Bridge Condition Review

Diamond Creek Vineyards Use Permit Major Modification P19-00177-MOD and
Exception to the Roads and Street Standards
Planning Commission Hearing – January 21, 2026

RE: Bridge Conditions Review
ZFA Job No.: 21695

RE: Diamond Creek Bridge Review and Recommendations

Photo 1: West arch foundation

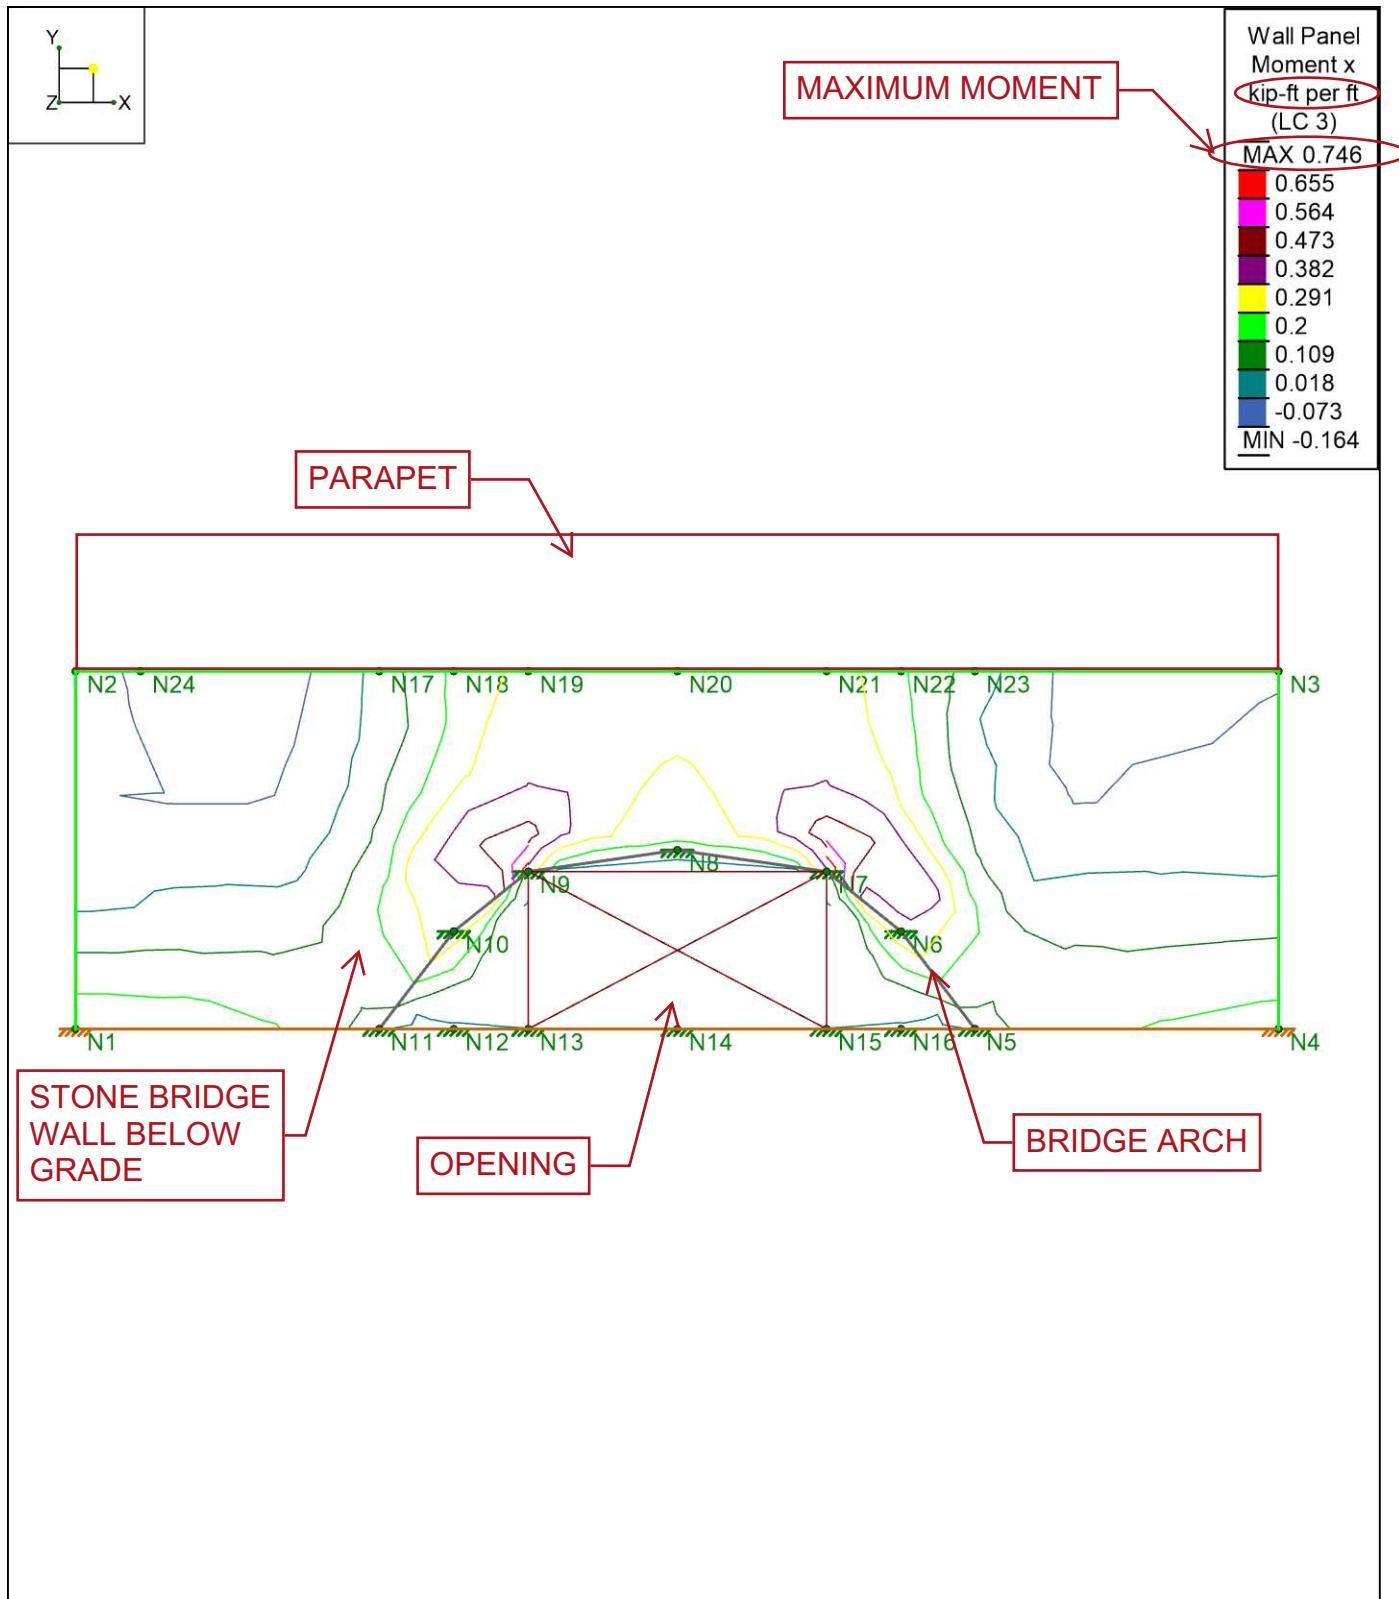
1. The erosion undermining the west arch foundation has worsened since the original report, with measurements up to 27-inches horizontally perpendicularly underneath the stone arch foundation. This undermining could lead to loss of soil support of the bridge structure.

ZFA recommends that the undermined arch foundations be repaired to regain their full soil bearing support and protected from future erosion/scour. This repair could be conducted by structurally and completely filling the void under the undermined foundation walls with a concrete or soil slurry and covering the repair with rubble rock to reduce the risk of repeated erosion.

Any repair should be coordinated with the appropriate state and local jurisdictions. ZFA recommends these repairs to be commenced as soon as possible and completed prior to next winter's rainy season. Until this repair is in place, we recommend that the foundations and bridge be reviewed during each month from November to March to review for further erosion or signs of structural distress.

Spandrel Walls as Gravity Retaining Walls

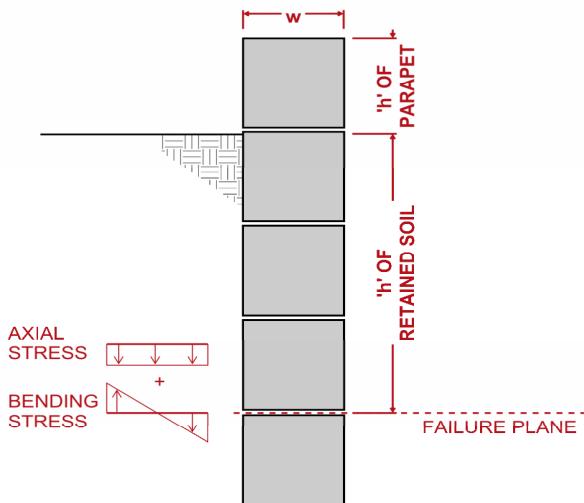
The Napa County comments also requested to update the previously provided load rating to include the entire bridge, including the unreinforced masonry (URM) head walls. Although the end wall thicknesses could not be directly observed or measured in the field, the wall thickness was assumed to be uniform to the parapet portion of the wall.

The wall was analyzed using an assume active loading of 40 pounds per cubic foot, and a soil surcharge load equivalent to an additional 2' of retained soil height was analyzed placed on the wall per AASHTO Table 3.11.6.4.2. The analysis concluded that the stress on the mortar was less than the allowable default lower-bound tensile strength per the ASCE 41-17 / Table 11-2a,

concluding that the head walls are adequate to support the vehicular surcharge loading and retained soil.
